KPB FILE NO. 2022-XX BIRCH FOREST NO. 3 PHASE ONE

ITEM 2 – BIRCH FOREST NO. 3

KPB File No.	2022-151
Plat Committee Meeting:	October 24, 2022
Applicant / Owner:	Poppin Family Revocable Community Property Trust of Soldotna, Alaska
Surveyor:	Jason Young, Mark Aimonetti / Edge Survey and Design, LLC
General Location:	Erlwein Road, Sterling

STAFF REPORT

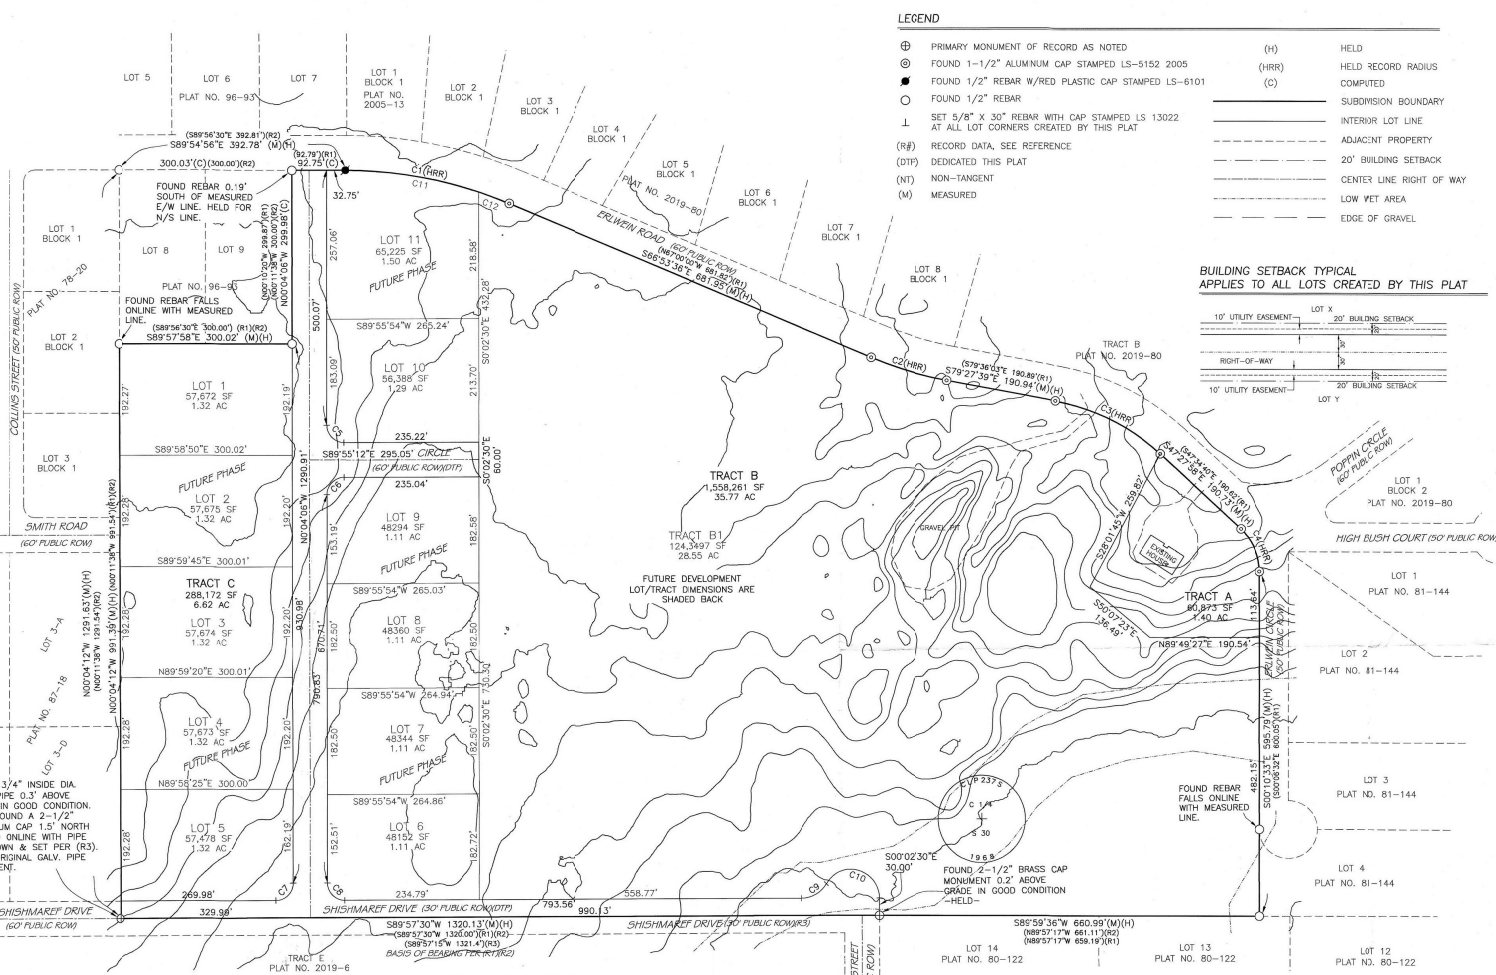
- *Have the building setback and utility easement typical depiction include side lot lines as the easements being granted include 20 feet within 5 feet of the side lot lines.*

Staff recommendation: *Area from the original plat for Tract A-s was 46.987 ac., you have listed 46.909 ac. in the title block, please verify.*

- F. The location, width and name of existing and platted streets and public ways, railroad rights-of-way, easements, and travel ways existing and proposed, within the subdivision;
Staff recommendation: *Approved names are required.*

- G. The status of adjacent lands within 100 feet of the proposed subdivision boundary or the land status across from any dedicated rights-of-way that adjoin the propose subdivision boundary, including names of subdivisions, lot lines, block numbers, lot numbers, rights-of-way; or an indication that the adjacent land is not subdivided;
Staff recommendation: *Update Poppin Circle to Court, High Bush Court was changed to Erlwein Road, Collins Street was changed to Frozen Street. Add block label for the lots south of the subdivision.*

- H. Approximate locations of low wet areas, areas subject to inundation, areas subject to flooding or storm water overflow, and the line of ordinary high water. This information may be provided on an additional sheet if showing these areas causes the preliminary plat to appear cluttered and/or difficult to read;
Staff recommendation: *Clarification of the wetland area may be needed.*

- L. Contours at suitable intervals when any roads are to be dedicated unless the planning director or commission finds evidence that road grades will not exceed 6 percent on arterial streets, and 10 percent on other streets;
Staff recommendation: *Verify for new dedications and for Erlwein Circle if requested by the plat committee.*

- O. If the subdivision will be finalized in phases, all dedications for through streets as required by KPB 20.30.030 must be included in the first phase.
Staff recommendation: *The north south right-of-way along with Shishmaref Drive and Erlwein Circle, will be required with the first phase.*

- B. Additional right-of-way or easement width may be required to provide for the construction of side slopes or to otherwise accommodate right-of-way construction standards set forth in KPB Title 14.
Staff recommendation: *Erlwein Circle is only dedicated as a 50 foot wide right-of-way, an additional 10 feet should be dedicated.*

Update plat note 2 by removing the reference to the building setback.

Wastewater notes will be required to be updated depending on how the owner wishes to have his soils analysis test done. Remove “or nominal five acres.”
